FINAL REPORT

SNOWDRIFT ASSESSMENT PROPOSED WASTEWATER LAGOON CLYDE RIVER, NUNAVUT

Project Number: 08-1023

February 29, 2008

SCALE 1:1500	CLIENT: GOVERNMENT OF NUNAVUT	JOB NO. OTCD19055A
DATE: 17/01/08	TITLE: CLYDE RIVER - ALTERNATIVE 3	FIG.7
DRAWN: MMR

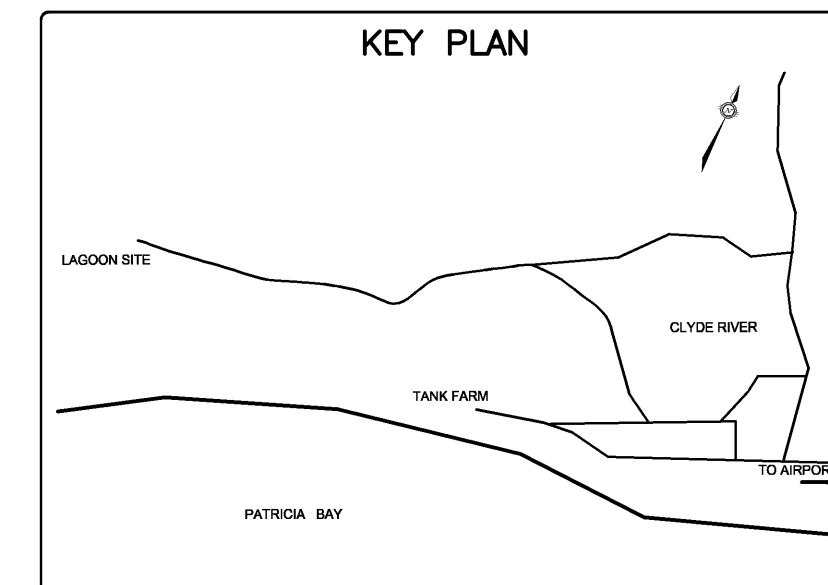
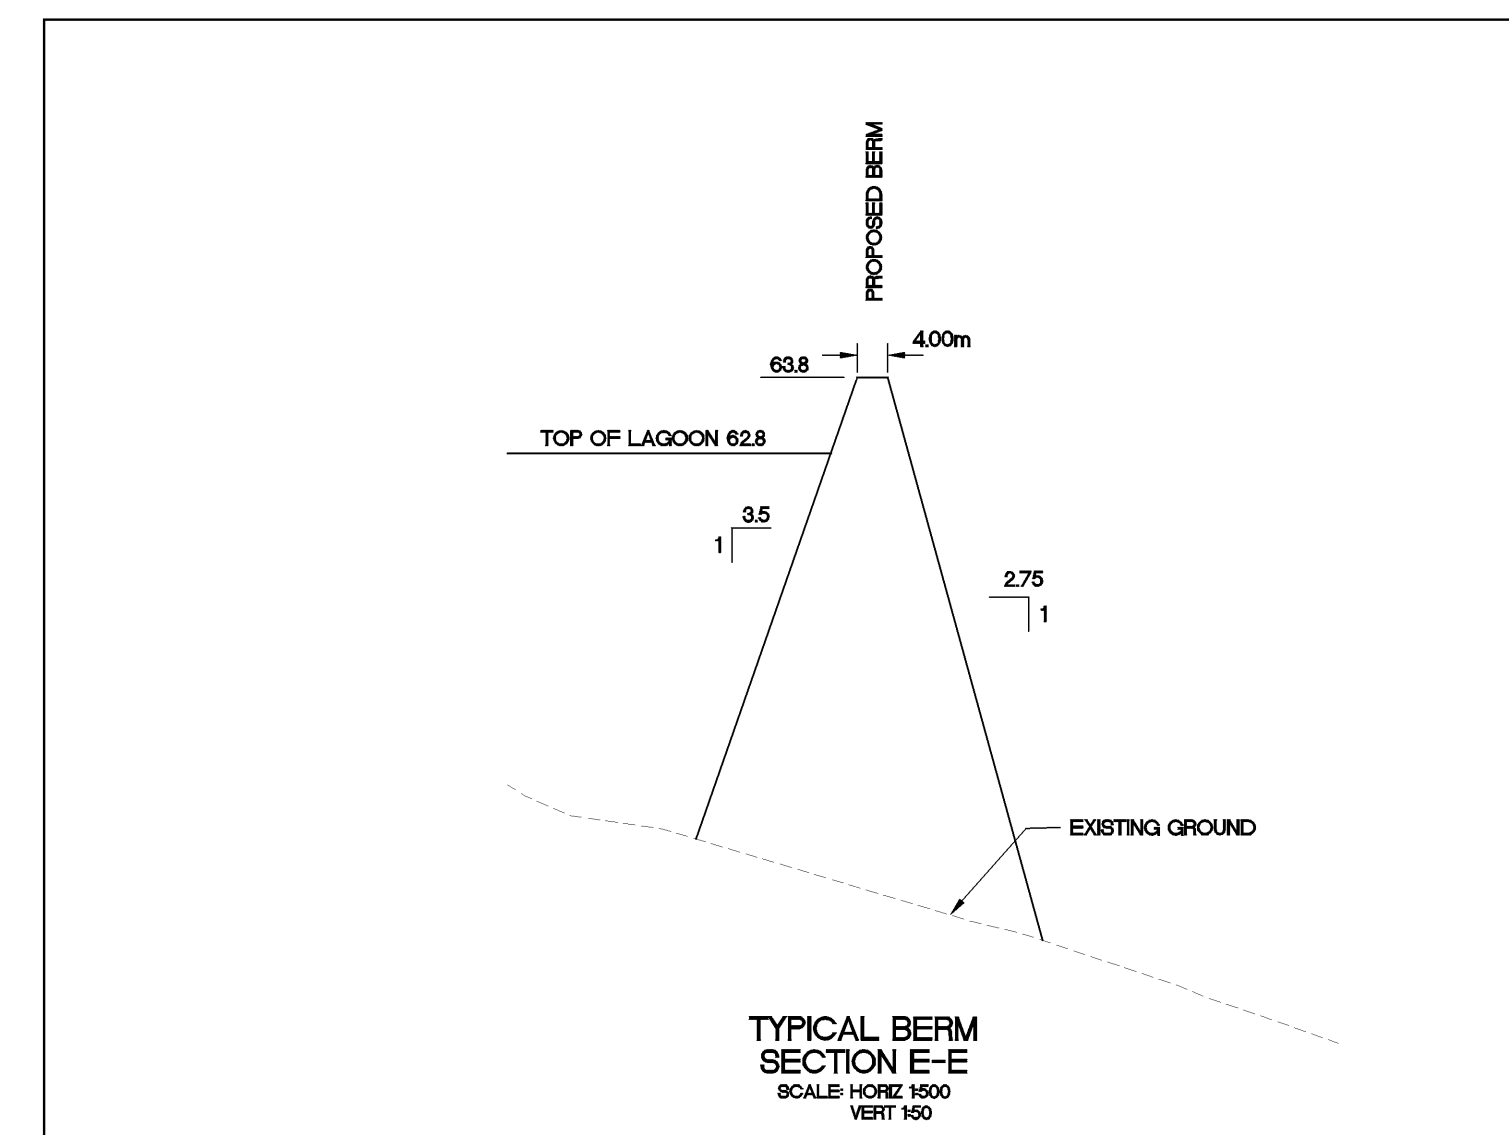
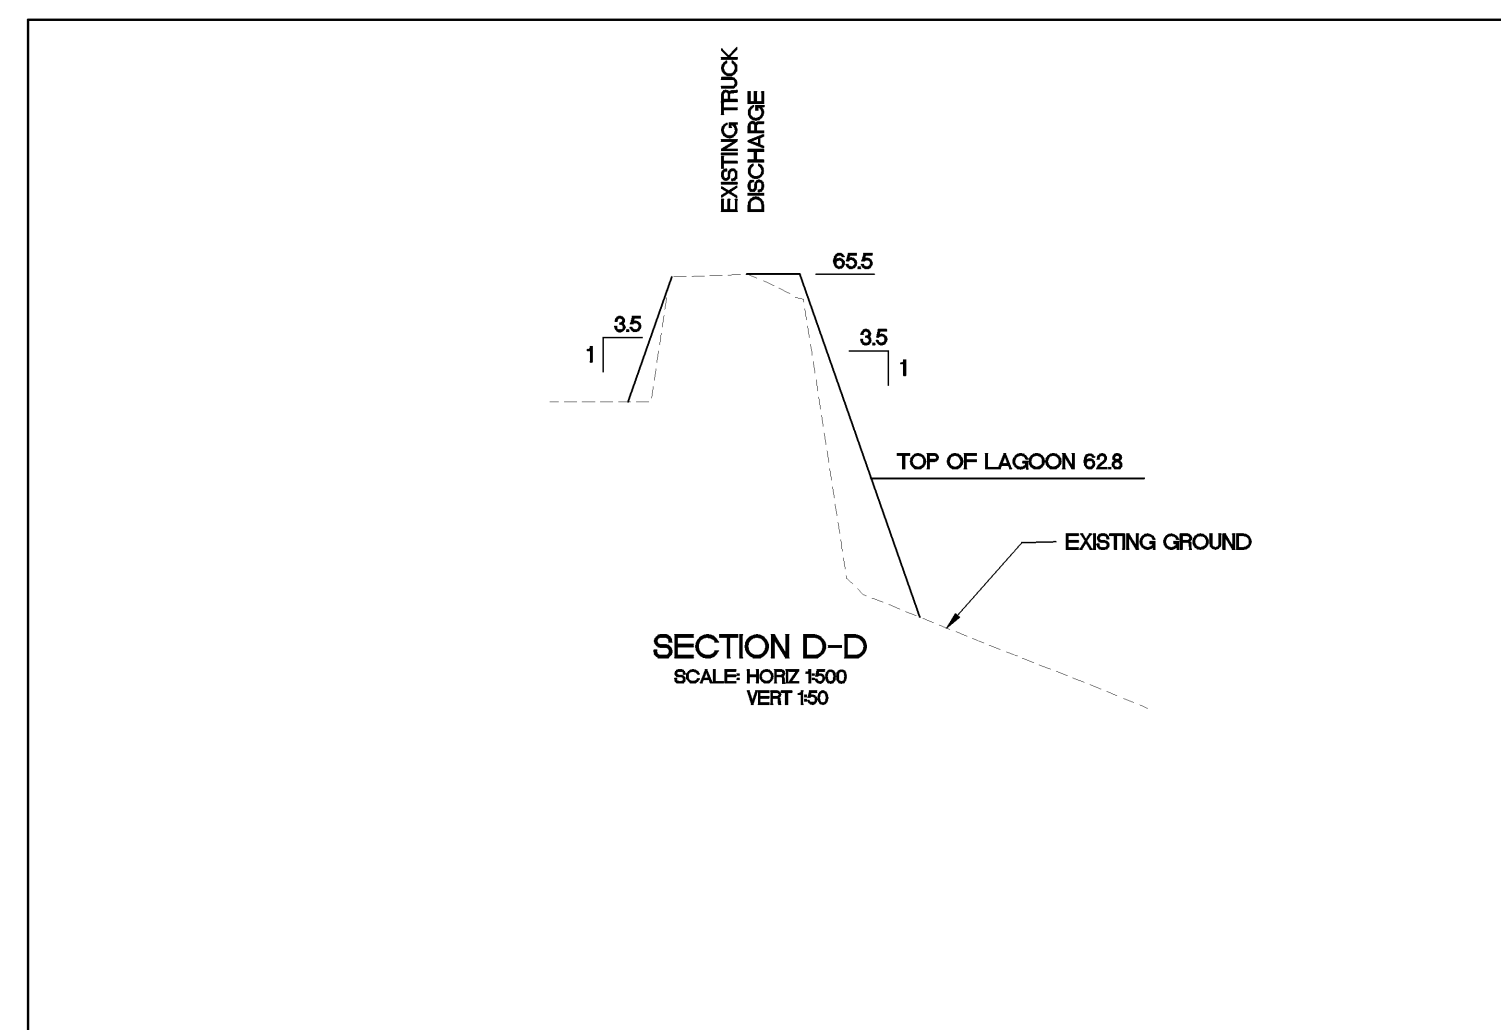
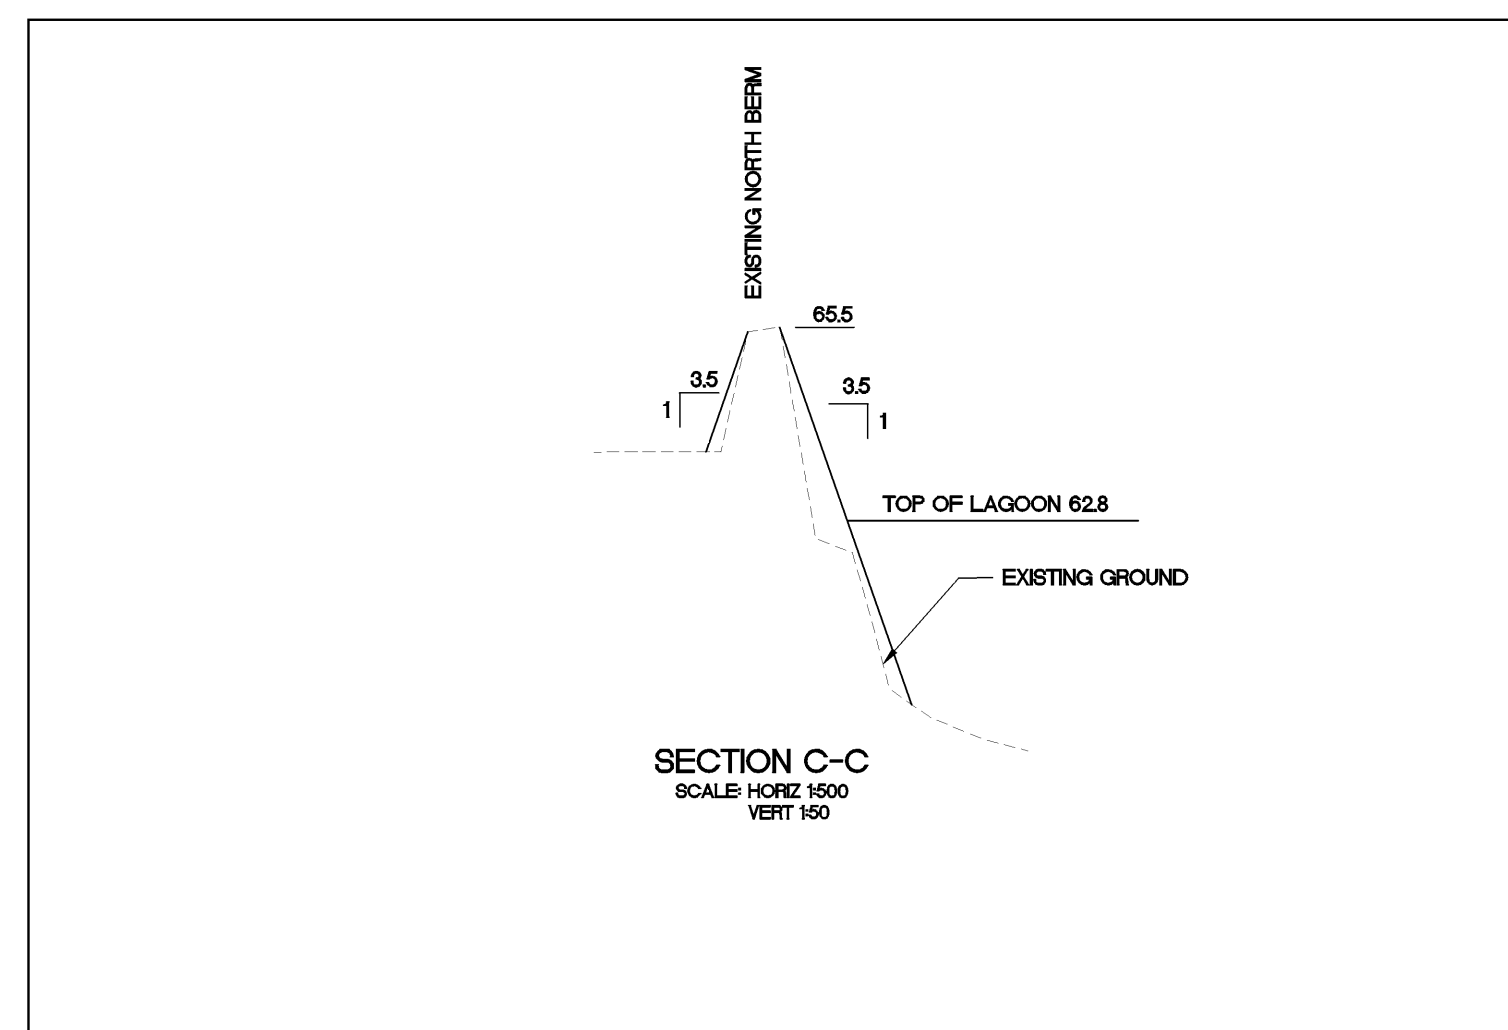
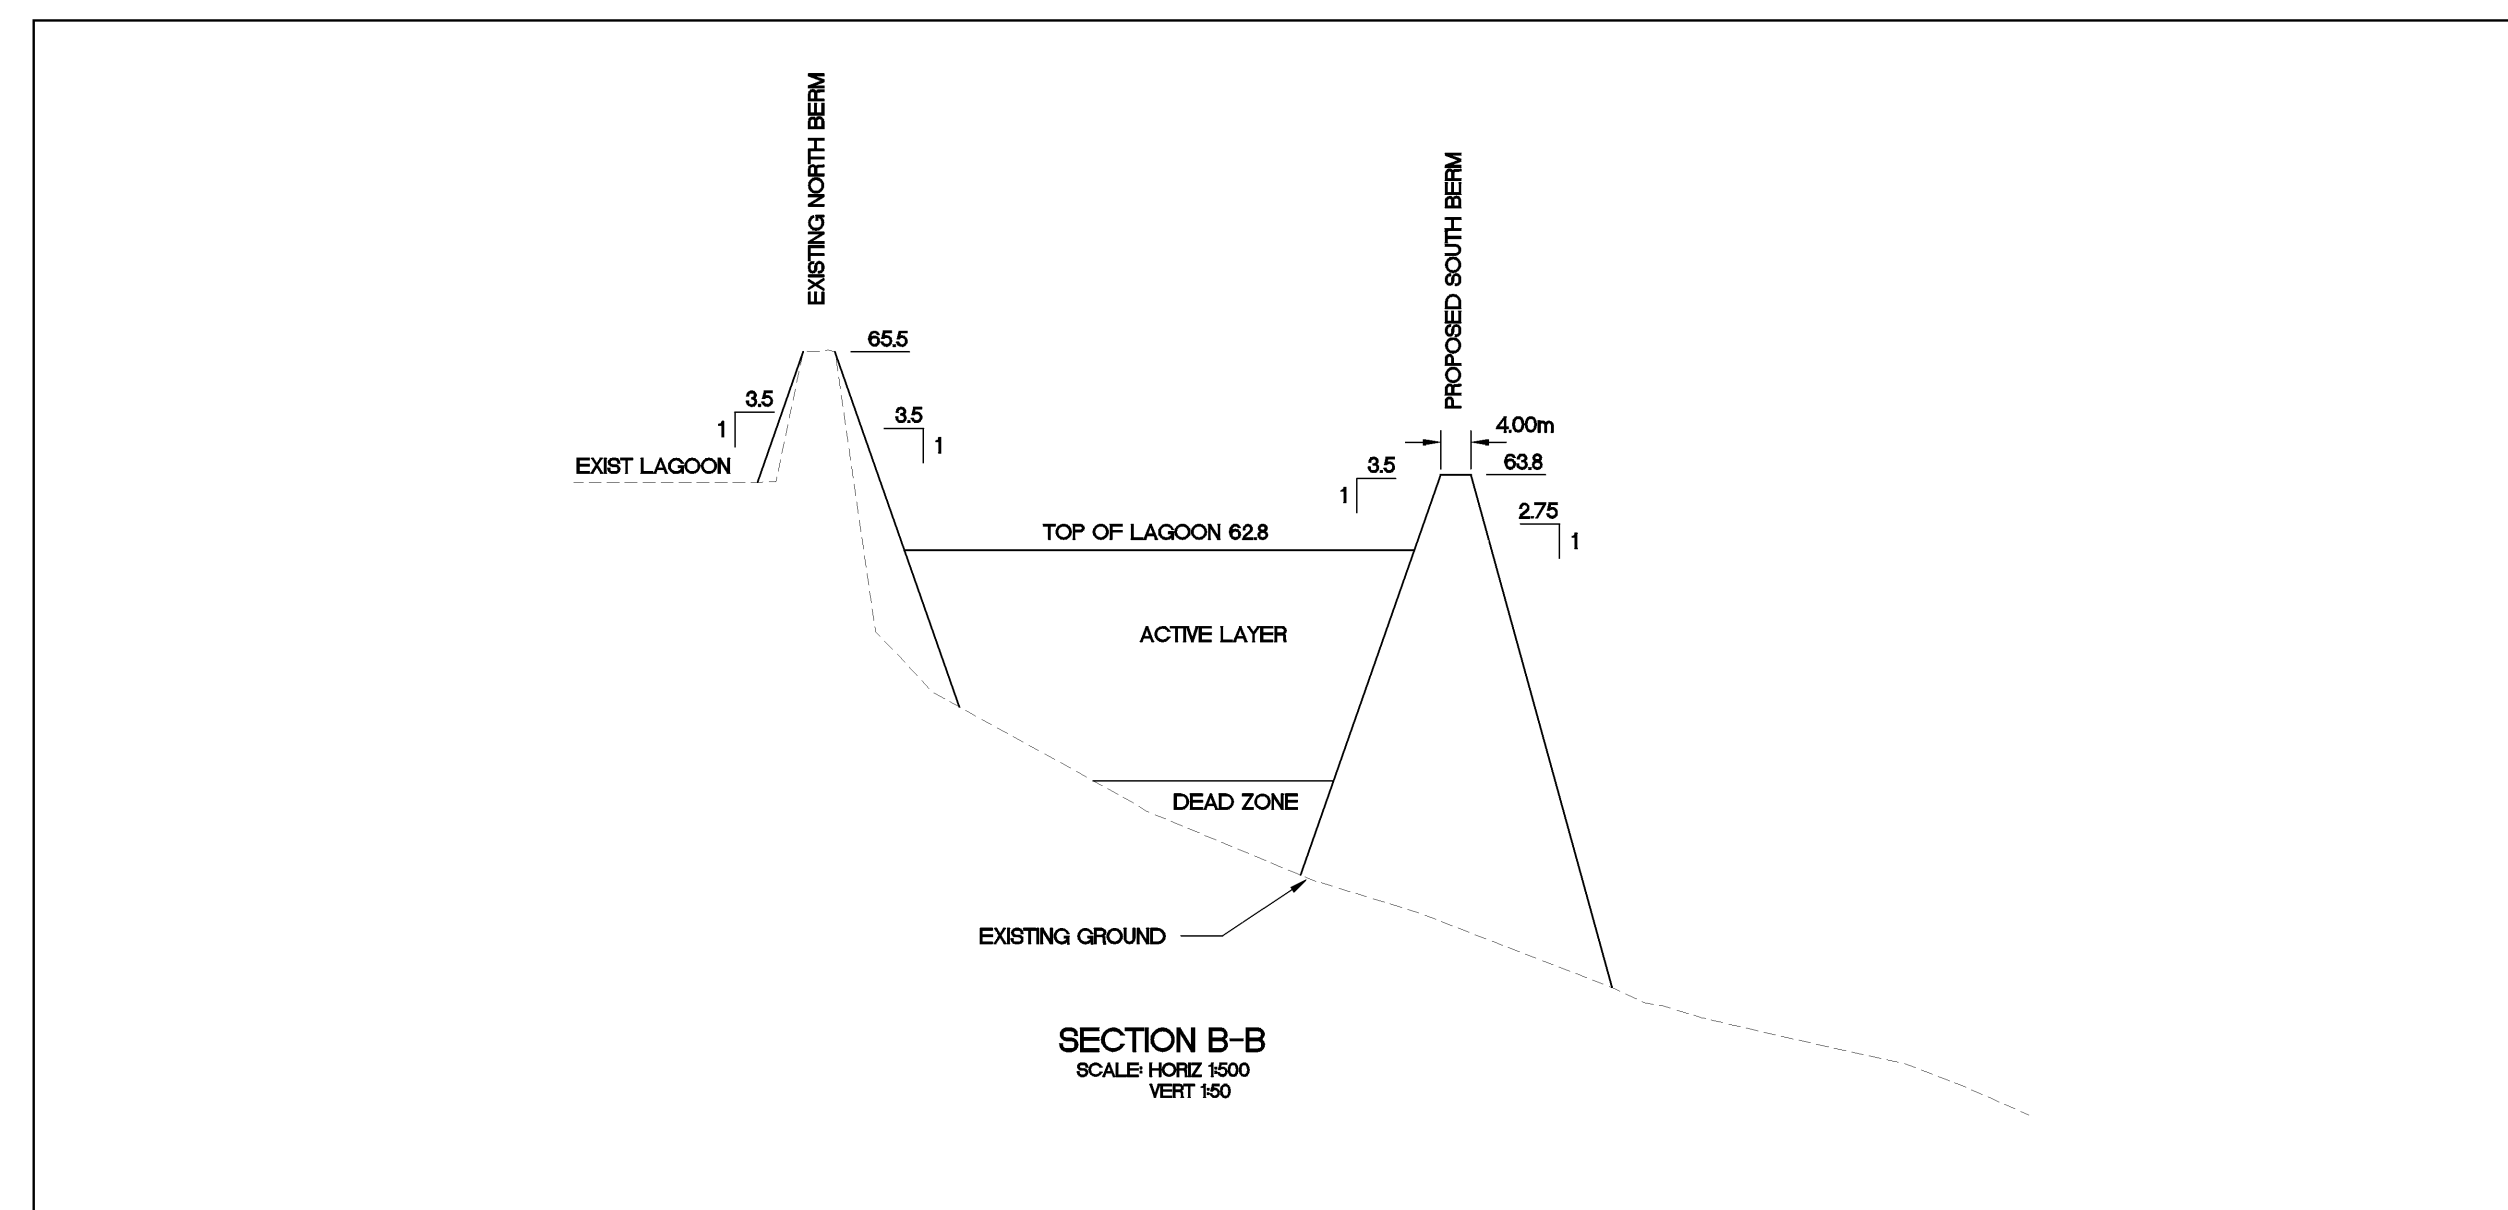
The main difference between Alternatives 3 and 4 is the presence of a second discharge point near the northwest "corner" of the existing lagoon in Alternative 4. The layout of the discharge area at the southeast "corner" of the existing lagoon is no different than the previous scheme we had reviewed, as per our final report you currently have. Those report comments would stand. The "northwest" discharge area is on the windward side of the lagoon. The safety barriers (e.g., boulders) are on the downwind (southeasterly) thus drifting on the traveled surface of the discharge area would be minimal.
